Planning App Ref:	PL/2025/09284
Service Ref:	Drainage
Date:	12/05/2026

Full application for removal of storage area for proposed Agricultural storage building and Padel Court use.

Lower Farm, Devizes Road, Rowde, Devizes, SN10 2LX

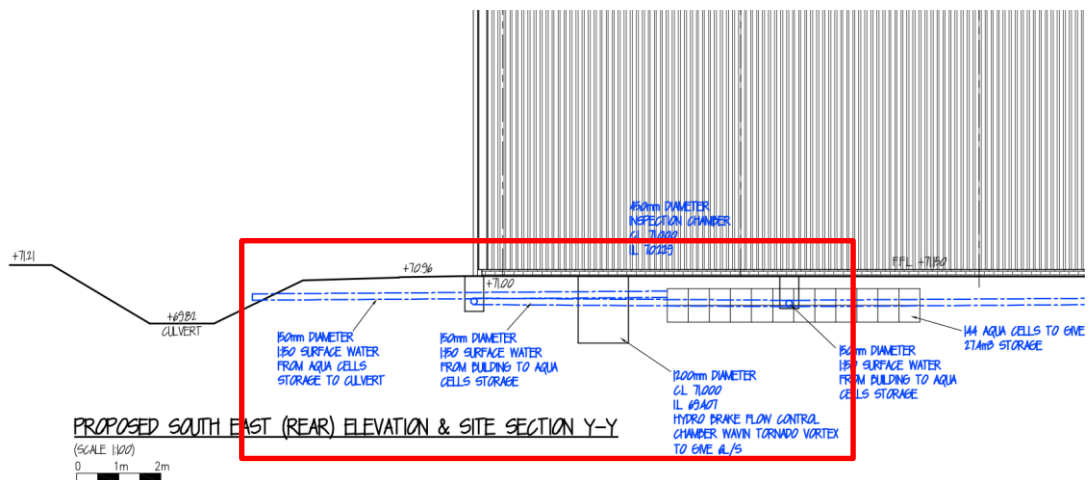
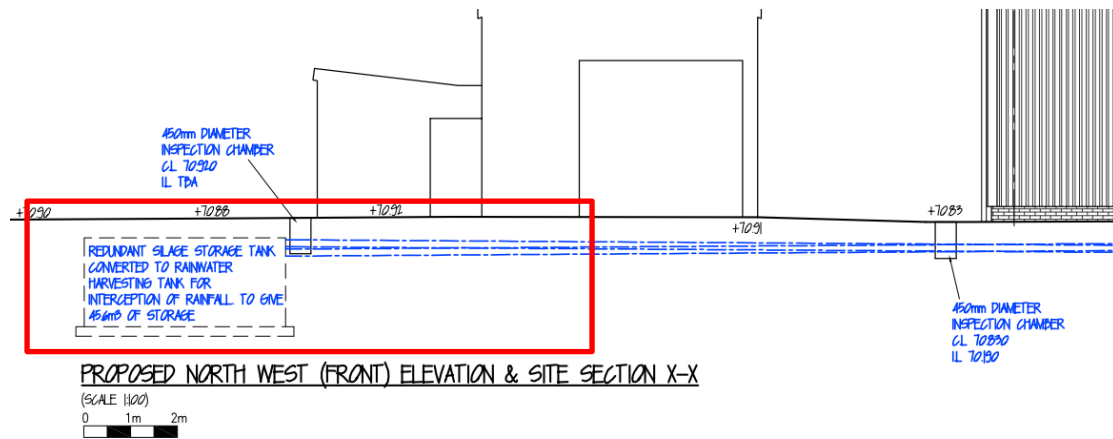
It is acknowledged that the applicant has submitted drainage calculations for greenfield runoff rates and attenuation volume requirements, along with a drainage network layout plan; however, it is unclear from the submitted calculations whether the proposed controlled discharge rate is 0.6 l/s or 6 l/s. If a discharge rate of 6 l/s has been adopted, it should be noted that this value appears to correspond to a rate expressed in litres per hectare per second (l/s/ha), and given that the site area is 0.07 hectares and provided calculation, the discharge rate ($\bar{Q}_A$) should be approximately 0.4 l/s; therefore, the applicant is requested to clarify the discharge rate used and ensure that it has been derived correctly in accordance with the site area.

- Pre and post development discharge rates. With regards the control of surface water discharges from brownfield sites, Wiltshire Council requires post development discharges to be as close as reasonably practicable to greenfield runoff for both peak flow and volume. For more information refer to Wiltshire Council's betterment policy update which can be found [here](#).
